EVALUATION OF PROPOSED PANEL CLOSURE MODIFICATIONS AT WIPP

Environmental Evaluation Group
New Mexico

December 2001

REVIEW OF PANEL CLOSURE BULKHEAD ENHANCEMENTS
WASTE ISOLATION PILOT PLANT (WIPP)

Figure 1. Exhaust drift longitudinal cross section through panel closure bulkhead

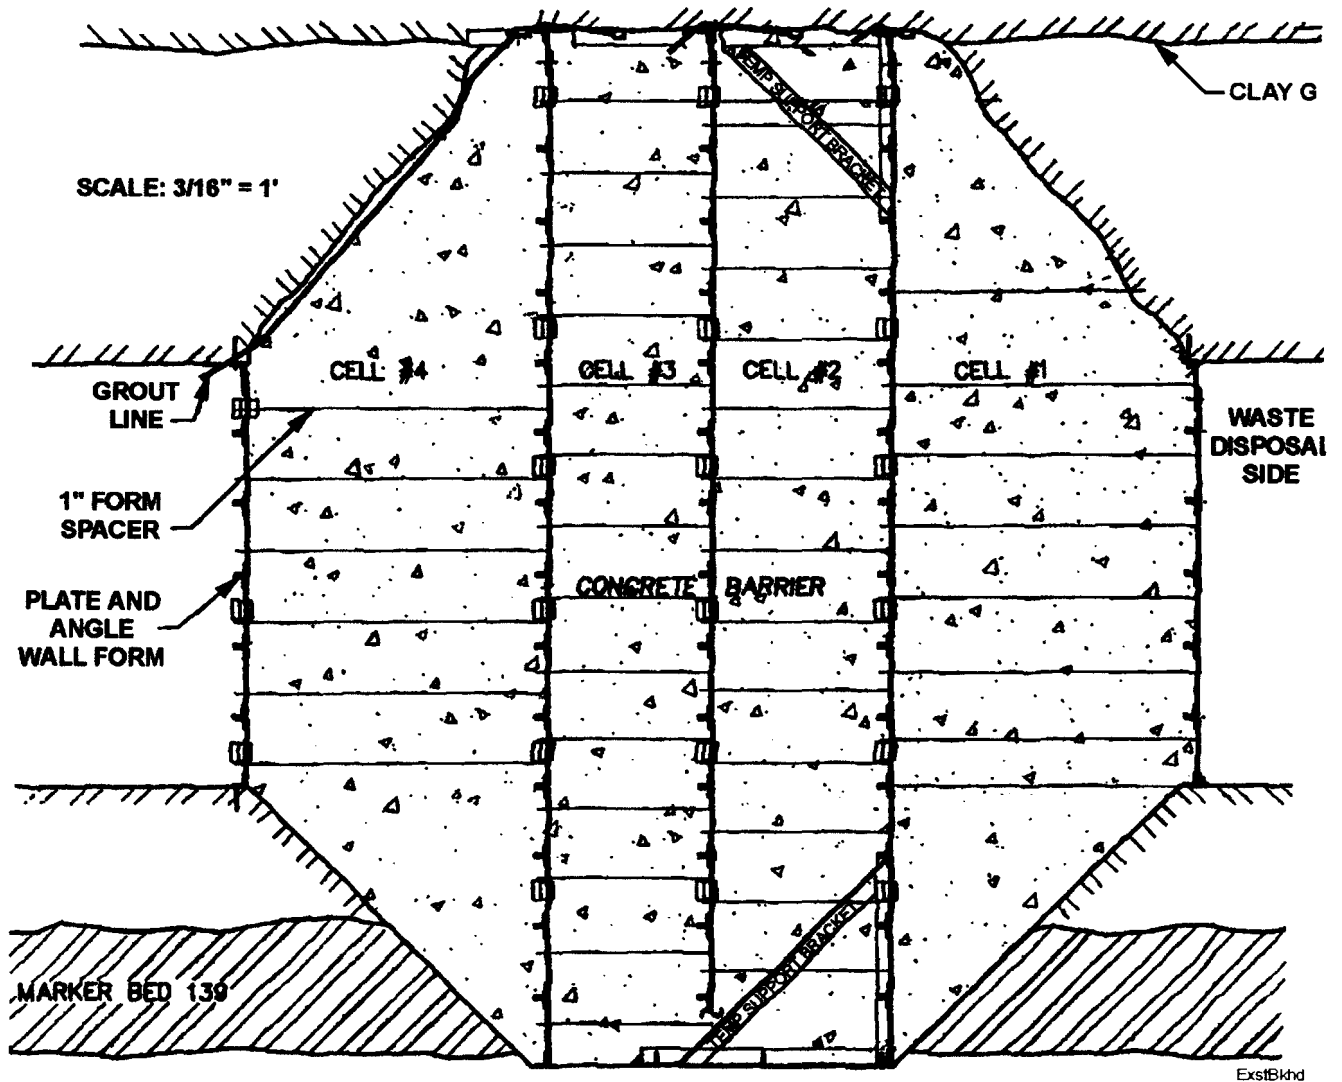
As indicated on Table 1, the strength of the 4,000 psi plain concrete panel closure bulkheads (Figure 1) is sufficient to resist the 480 psi design pressure from the postulated methane explosion, during and after the planned 35-year life of the facility. The strength of the 4-ft thick construction-isolation masonry walls is sufficient to isolate the panel closure bulkhead construction areas from the design pressure generated by a panel room roof fall. The 12-ft thick explosion-isolation masonry wall, (2,500 psi) solid concrete blocks (3,500 psi) mortared with cement (2,500 psi) and hitched 6-in into the adjacent rock salt, designed for the Intake Drift and the Exhaust Drift is insufficient to resist the 480 psi methane explosion pressure (Figure 2). There is no apparent reason for an explosion-isolation wall during the six-month or one year construction of the panel closure bulkheads. Methane concentration will not increase until panel ventilation is stopped, which should only start when construction starts on the isolation walls (Figure 3).

the reason that the two-way tapered plain concrete bulkheads, shown on Figure 1, were designed.

The panel closure bulkhead design (Figure 1 and Figure 10) is not a monolith because it is planned to be built using four

In order of declining potential effectiveness, the following panel closure bulkhead construction modifications should decrease the bulkhead leakage potential,

- 1) constructing truly monolithic single-cell panel closure bulkheads or
- 2) externally supporting the bulkhead cell forms, i.e. eliminating the form spacers, or
- 3) reducing the number of cells.

Figure 2. Explosion-isolation masonry wall bulkhead

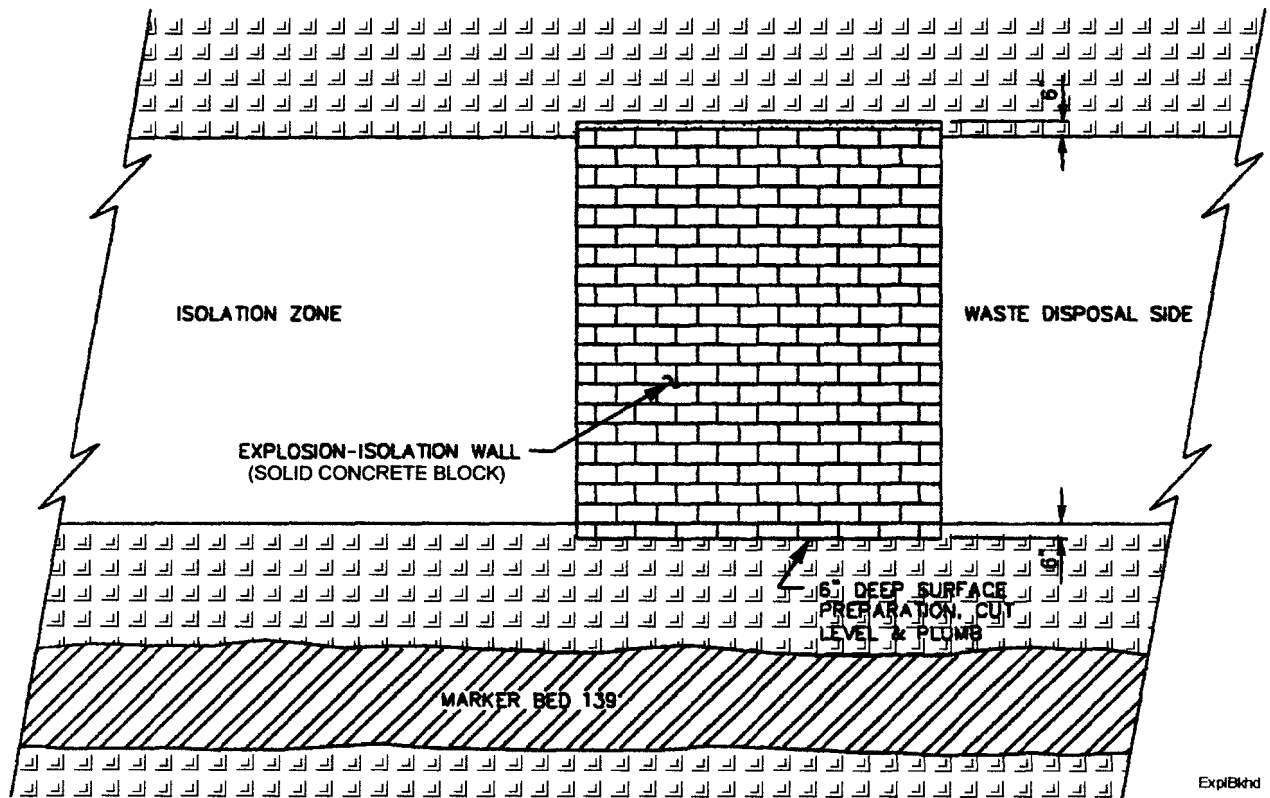
The 12-ft thick explosion-isolation masonry walls for the Intake Drift and the Exhaust Drift (Figure 2) are planned to be built with solid concrete blocks (3,500 psi) mortared with cement and hitched 6-in into the roof, ribs and floor. The explosion-isolation masonry wall is apparently designed to resist the 480 psi methane explosion pressure during the six months to one year of panel bulkhead construction.

The ability of the planned explosion-isolation masonry walls to resist the 480 psi methane explosion pressure was conservatively checked using the water impoundment bulkhead design method (Abel, 1998). Table 1 presents the results of this analysis. The calculations for the Intake Drift are presented in Appendix C and for the Exhaust Drift in Appendix D. The results of this analysis predicts that the planned 12-ft thick explosion-isolation masonry walls would not be capable of resisting the 480 psi design methane explosion pressure. The predicted failure of the explosion-isolation wall is indicated on Figure 12. In the Intake Drift, the thickness of an explosion-isolation masonry bulkhead would have to be approximately 20-ft to contain the 480 psi methane explosion pressure and in the Exhaust Drift approximately 15-ft.

Figure 3. Methane concentration in waste panel over time

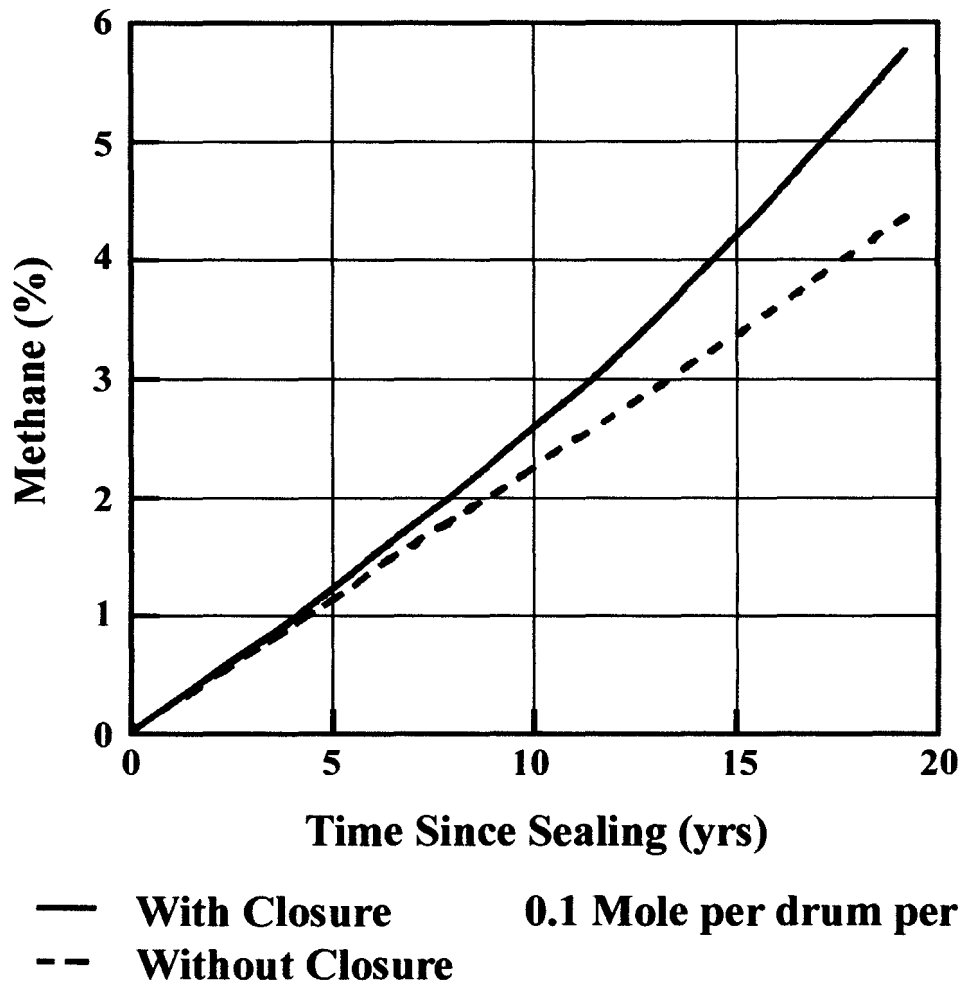
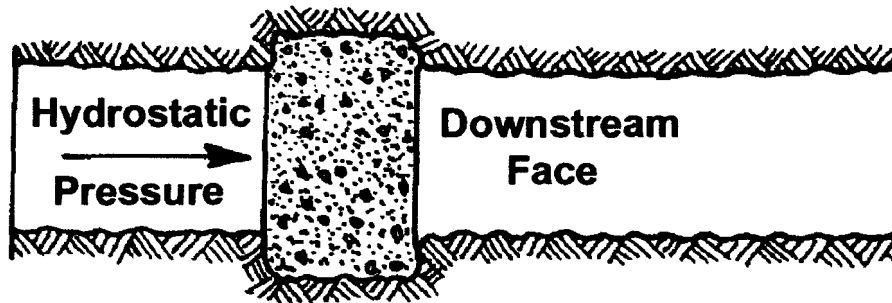
The ground pressure applied to all sides of the panel closure bulkheads during the 17 years needed to reach an explosive 5% methane concentration (Figure 3) will grip the top, bottom and sides of the bulkheads. The force of this grip will resist flexure of the bulkhead concrete, in effect forming a fixed-end circular deep plate. The fixity of the panel bulkheads will reduce the bending moment developed when the bulkhead is loaded by the design explosion pressure applied from the waste emplacement side.

Figure 3 presents the predicted 17+ year methane concentration time interval between cessation of panel ventilation and the methane concentration reaching the minimum 5% lower explosive limit. The predicted methane concentration should not exceed approximately 0.25% during a one-year panel closure bulkhead construction period. Therefore, a methane explosion should not be possible, and an explosion-isolation masonry wall not necessary.

Figure 10. Optional designs for panel closure systems

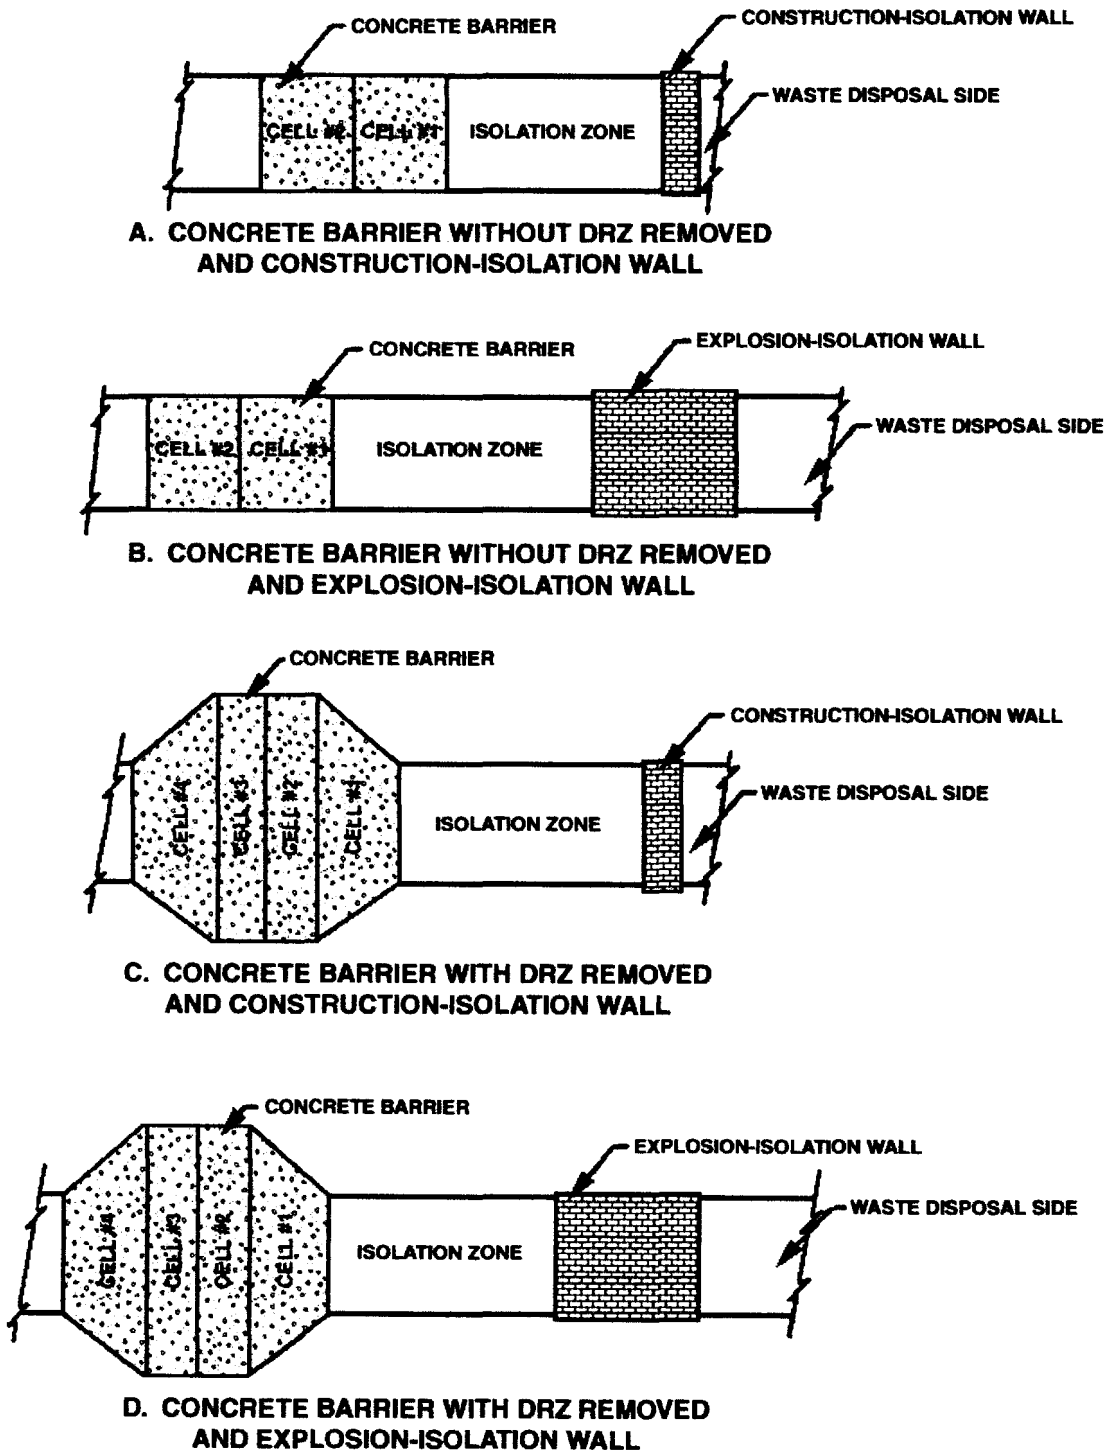
Parallel panel closure bulkheads would probably be successful in resisting the potential applied pressures, Options A and B on Figure 10. However, the progressive deterioration of the adjacent rock salt and anhydrite and clay layer bed separations suggests that the two-way tapered bulkhead will assure the long term functioning of airtight panel closure bulkheads.

Figure 16. Pressure transient from a roof fall

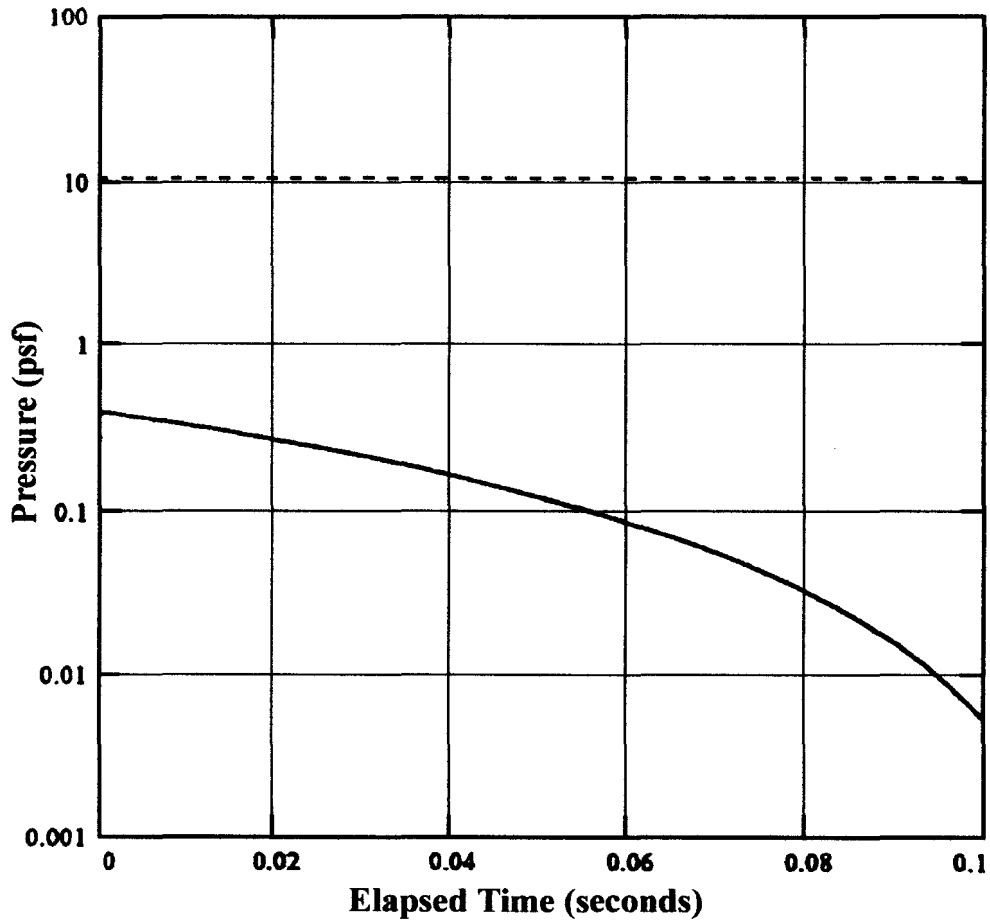
A 4-ft thick construction-isolation masonry wall has been designed to isolate the panel closure bulkhead construction from the emplaced waste in a completed panel and from the transient overpressure from a 15,000 ton roof fall in central 140-ft of Room 1 in the completed panel, closest to the Intake and Exhaust Drifts. The design roof fall is equal in weight and length to the roof fall in Site and Preliminary Design Validation Room 1 (SPDV1). The SPDV1 fall distance was the 13-ft room height, whereas the fall distance with emplaced waste drums is limited to 3.5-ft. Figure 16 presents the predicted 0.4 PSF (0.003 psi) maximum overpressure and the design 10.1 PSF (0.070 psi) air overpressure from the roof fall.

The ability of the planned construction-isolation masonry walls to resist the 0.070 psi design roof fall pressure was conservatively checked using the water impoundment bulkhead design method (Abel, 1998). Table 1 presents the results of this analysis. The calculations for the 4-ft thick Intake Drift construction-isolation masonry wall are presented in Appendix E.
